**4349B-05**

# S E R V I C E N O T E

## 4349B 4-Channel High Resistance Meter

### **Remedy for OVLD display due to incomplete soldering of capacitor on A1 board**

Figure 1. Example of capacitor which was easily pulled out with the check.

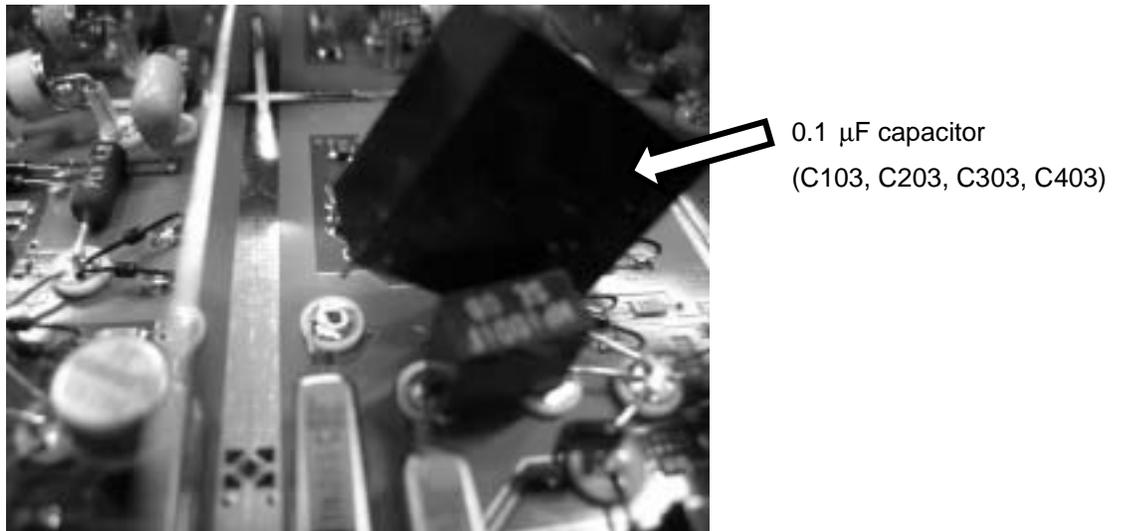
These 4349B units have possibility that one or some of 0.1  $\mu\text{F}$  capacitors C103, C203, C303 and C403 on the A1 board assembly is not firmly soldered to a multi-terminal on the board. If the capacitor lead is not completely soldered, the integrator at input stage malfunctions.

When the 4349B exhibits the aforementioned symptom, check the capacitors C103, C203, C303 and C403 on the A1 board for defective soldering. Try to pull up the capacitor located in the faulty measurement channel. If the capacitor lead is pulled out or not firmly soldered, replace the A1 board with new one.

(See Figure 1 for an example of capacitor, which was easily pulled out with this check.)

Note: Re-soldering the capacitor should be avoided because the capacitor lead may not be easily soldered. In some cases, the length of capacitor lead may be too short.
